## ***Interactive comment on “Future changes in Mekong River hydrology: impact of climate change and reservoir operation on discharge” by H. Lauri et al.***

**H. Lauri et al.**

Received and published: 17 August 2012

**Fig. 1.** Table where tributary validation of hydrological model is presented

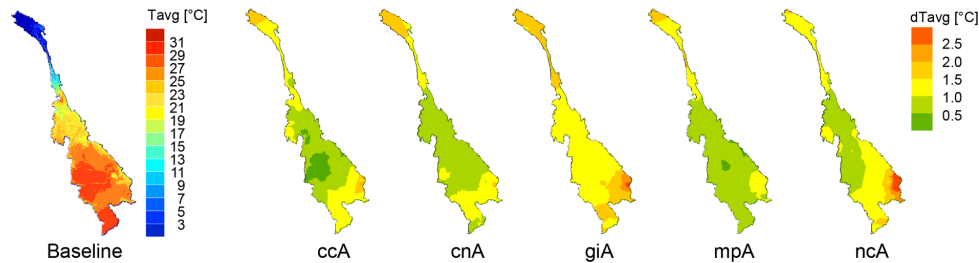
REVIEWER#1: 2. Specific comments 2.1 The calibration was performed mainly based on one time series (discharge at Stung Treng). However, tributaries in the basin contribute very differently to total runoff during dry and wet season. For example, an important contribution to the flood hydrograph comes from the sub-catchments on the mountain range along the border between Vietnam and Laos. One can imagine that any of your CC scenarios will cause a change in spatial precipitation patterns, which may reinforce or weaken the importance of these sub-catchments (Eastham 2008). Since you did not present any measure of the efficiency for tributaries, it is impossible for the reader to know if the spatial heterogeneous climate change signal will be well translated into the hydrology of the basin. In simpler terms, there is an equifinality problem that has to be accounted for in the final uncertainty estimation, or at least discussed more thoroughly.

Due to the very sporadic discharge data in the Mekong tributaries, we were not able to validate the model in those in detail within this project. In a separate ongoing project, we have validated with updated VMod model application to the Mekong (with 1 km model grid) the model performance in three tributaries with data for more than ten years (Ban Tha Kok Daeng, Sebang Fai, Ban Kamphun). Attached (Fig 1 of the response attachments) is the summary of the results.

In these tributaries the model performed rather well. This is, however, yet unpublished data and we cannot refer to it yet. But we believe that those validation results in six mainstream stations together with this preliminary information from three tributaries confirm that the model is performing well in all the sections of the basin.

Fig. 2. new Fig 3 for the main text

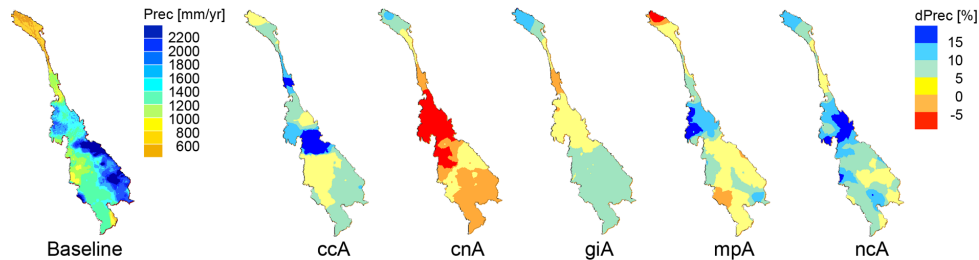
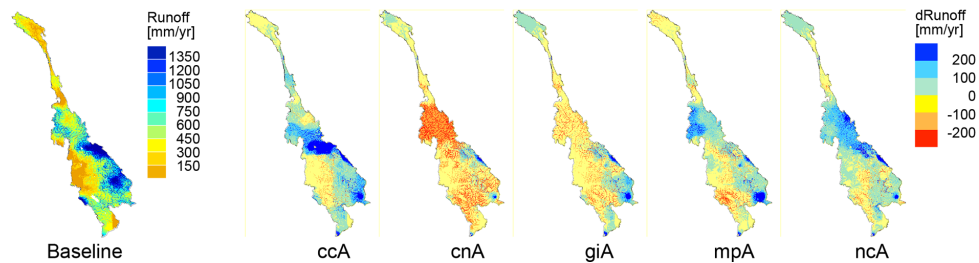
To compensate, some parts could be presented in the supplement and not in the main manuscript (or even deleted). The description of the meteorological data including Fig. 1 could be moved to the supplementary material. The spatial distribution of the stations is normally important, but you don't present any model result concerning spatially distributed variables, so you don't need to show the spatially distributed input. Instead, you should present a spatially distributed model result, like soil moisture or annual runoff in order to strengthen the model validation. The same applies to the description of the statistical downscaling methodology. There are enough papers out there dealing with this topic and unless you discuss the contribution of the downscaling to the uncertainty of your estimations (which you should) you don't need to describe it and may move it to the supplement (or simply delete it).

To enhance the spatial understanding of the model performance and climate change impacts on hydrology, we added a new tile to Fig. 3 (Fig. 3C), where we present spatially the simulated runoff and how the climate change impacts on it. This gives much better picture on the heterogeneity of the issue. Moreover, we added a spatial pattern for average temperature (Fig 3A) and average precipitation (Fig 3B). The new Fig 3 is attached to this response as Fig 2. The runoff results are also briefly discussed in the main text and basin wide change in runoff due to climate change is summarised in Table 5.

We agree that it is good to also include spatially distributed model results. We thus added the following figures to the paper - Baseline for temperature and precipitation to Fig 3A and Fig 3B, respectively - New tile to Fig 3 (Fig. 3C), where spatial runoff map and impact of climate change on runoff are presented
